ADDENDUM NO.2 TO THE CODE OF PRACTICE ON SURFACE WATER DRAINAGE (7TH EDITION)

This circular informs Developers, Qualified Persons (QP) and Agencies that PUB will be issuing Addendum no. 2 to the Code of Practice on Surface Water Drainage (COPSWD) (7th Edition) on 16 October 2023.

Annex C – Drawing No. 7C

DRAWING NO. 7C

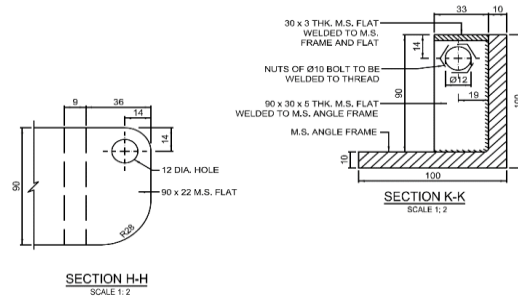
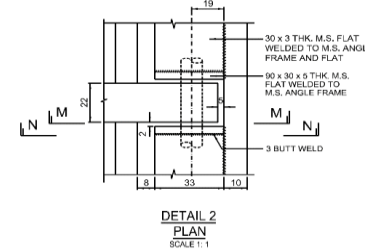
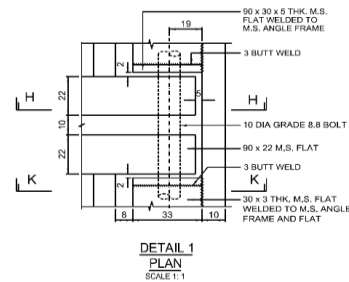
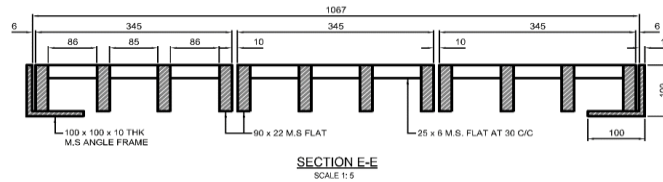
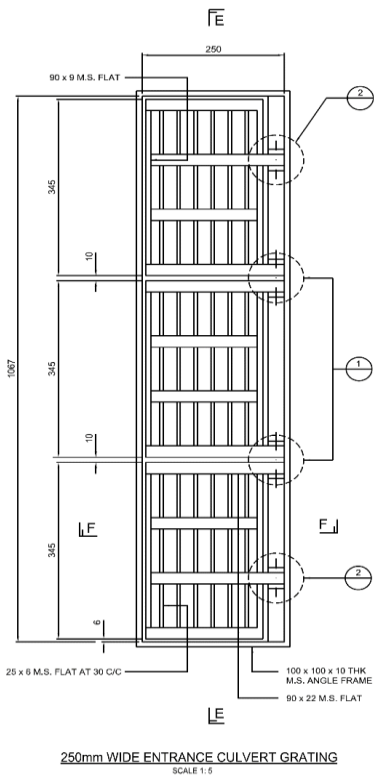
Clause	COP 7 th Edition Existing Clause	Amended Clause	Remarks on Changes
9.12.2	<p>Entrance Culvert/Crossing</p> <p>Under the exceptional circumstance where the entrance culvert/crossing is shallower than 600 mm or when requested by the Board, hinged open gratings shall be installed throughout the whole length of the entrance culvert/crossing.</p>	<p>Entrance Culvert/Crossing</p> <p>Under the exceptional circumstance where the entrance culvert/crossing is shallower than 600 mm or when requested by the Board, one number of hinged open gratings as per Drawing no. 7C shall be installed in the middle of the entrance culvert/crossing</p>	<p>To standardise entrance culvert grating design and align with LTA's SDRE requirements. See Annex C for the new Drawing no. 7C.</p>
